**NTE TO ADD NOTED FEATURES OF THIS DRAWING TO LIGO P/N D060493.**

DSG093 Redline (v2) PART PDM REV-X-022 DRAWING PDM REV-X-003

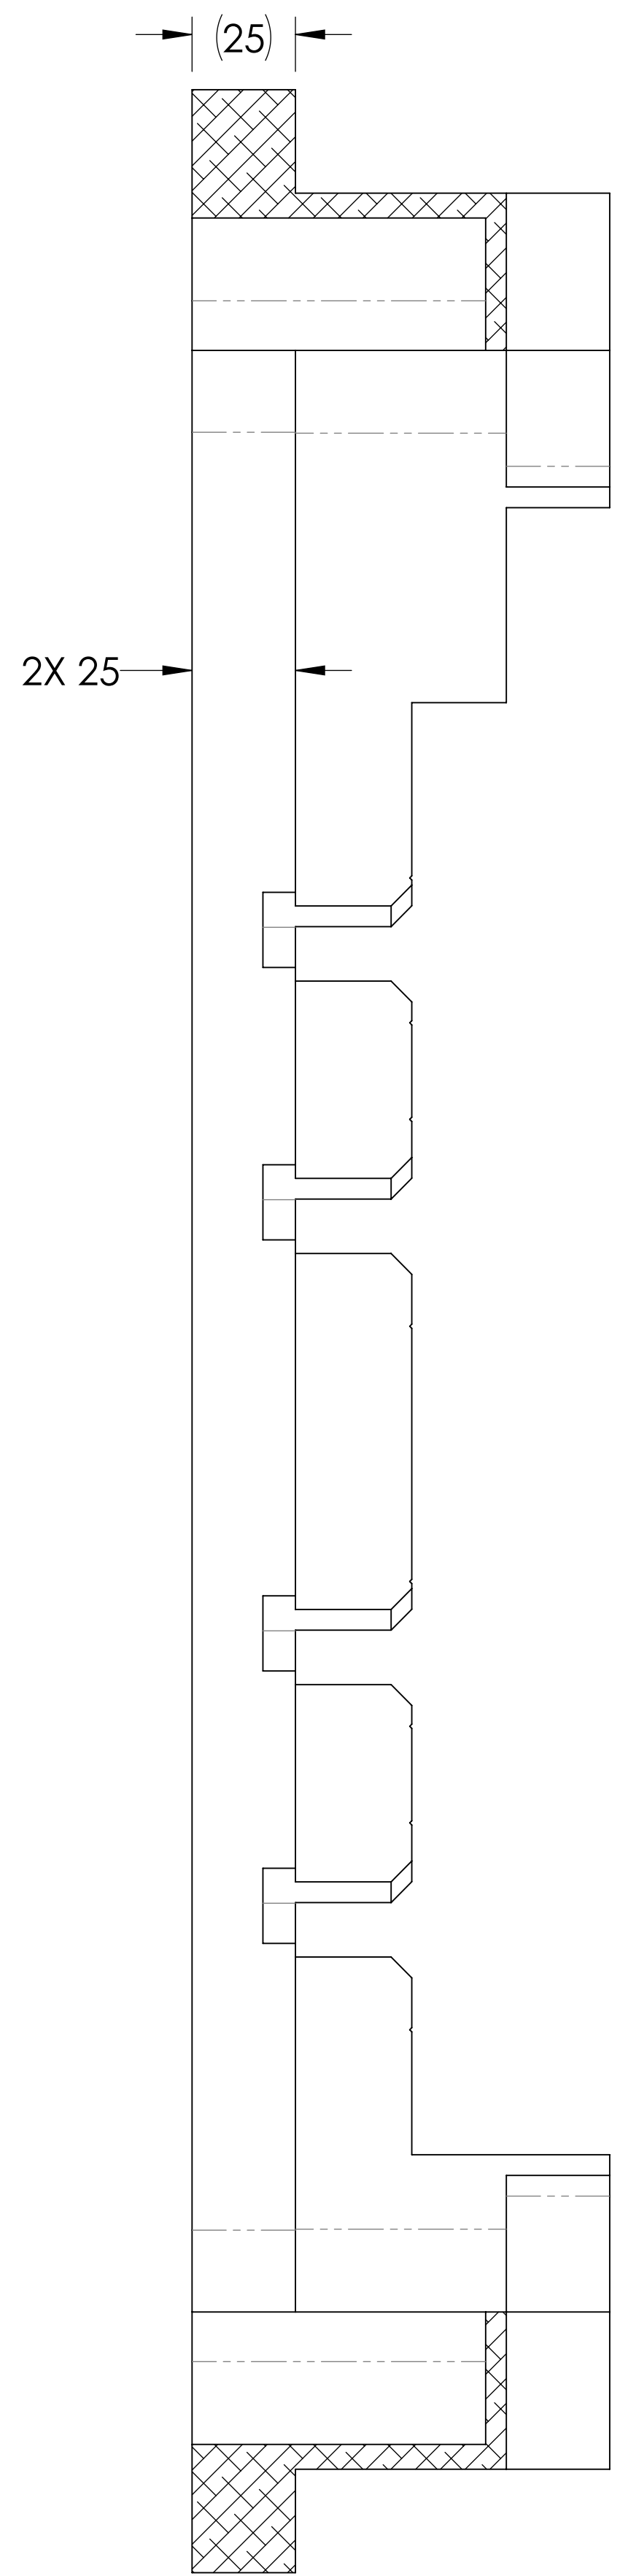
ADDED FEATURE DETAIL TYPICAL

**FOR REVISION ADD NOTED FEATURES**

SECTION A-A

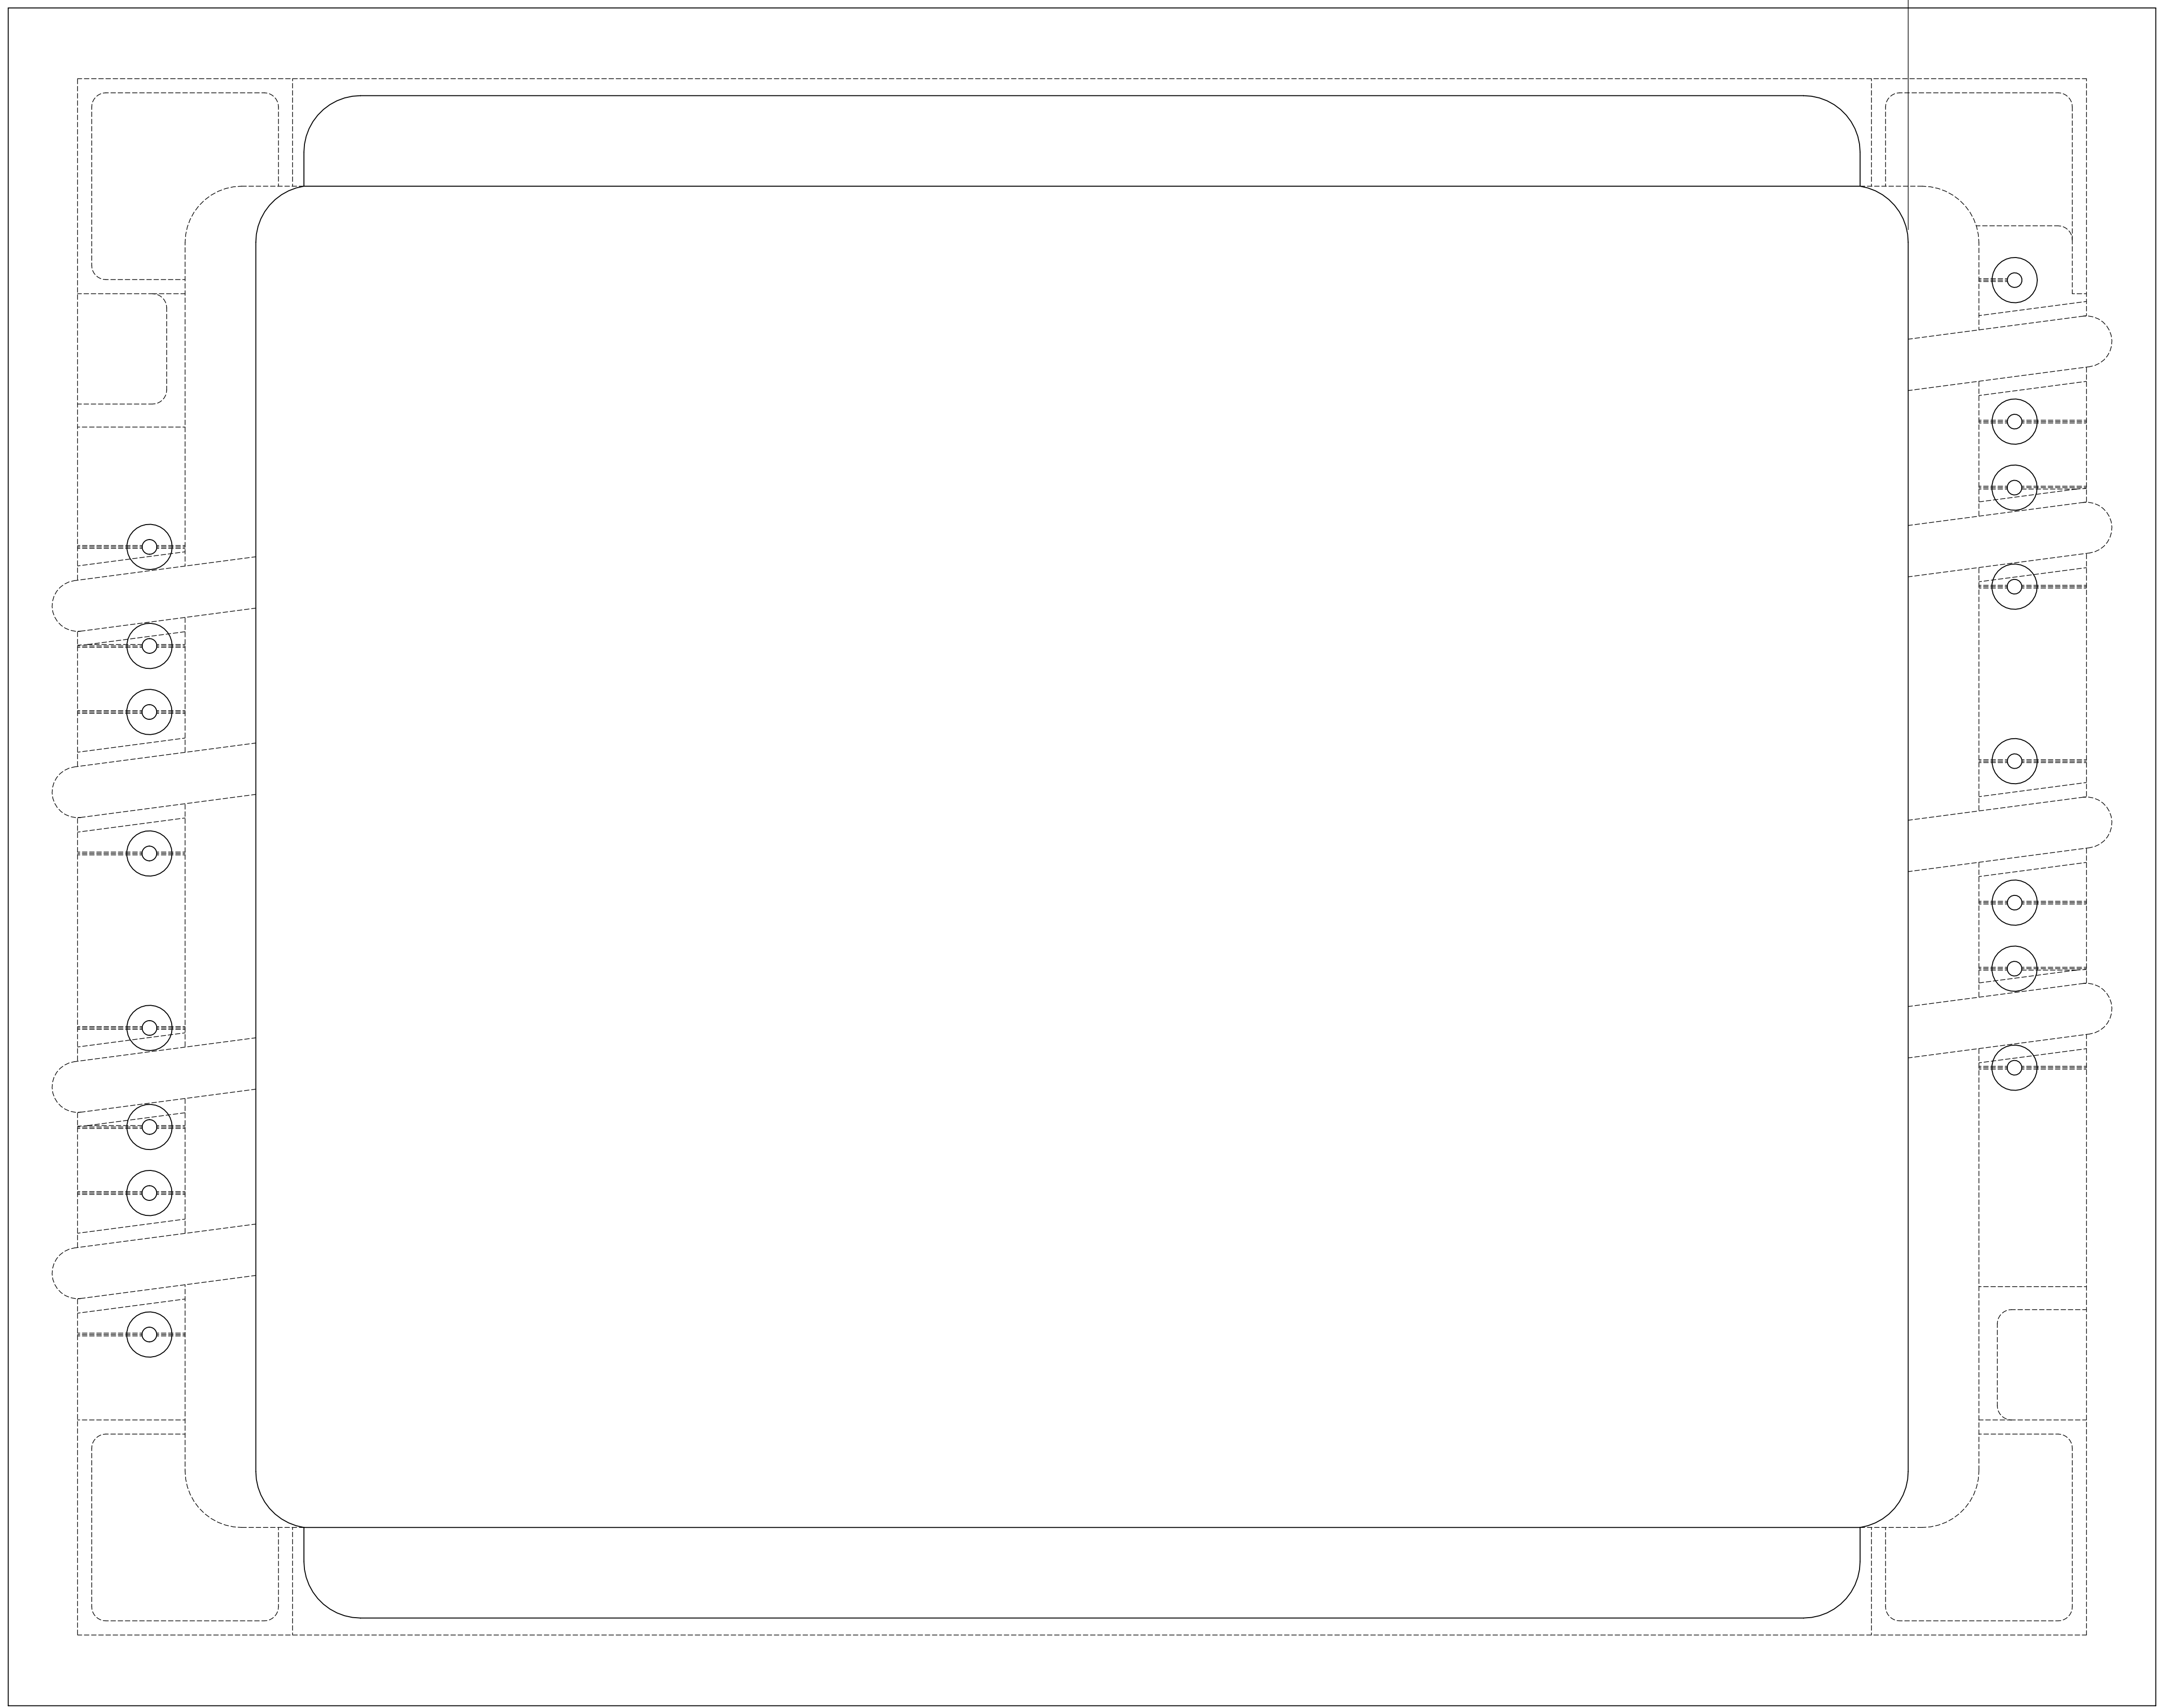
FOR REVISION ADD NOTED FEATURES
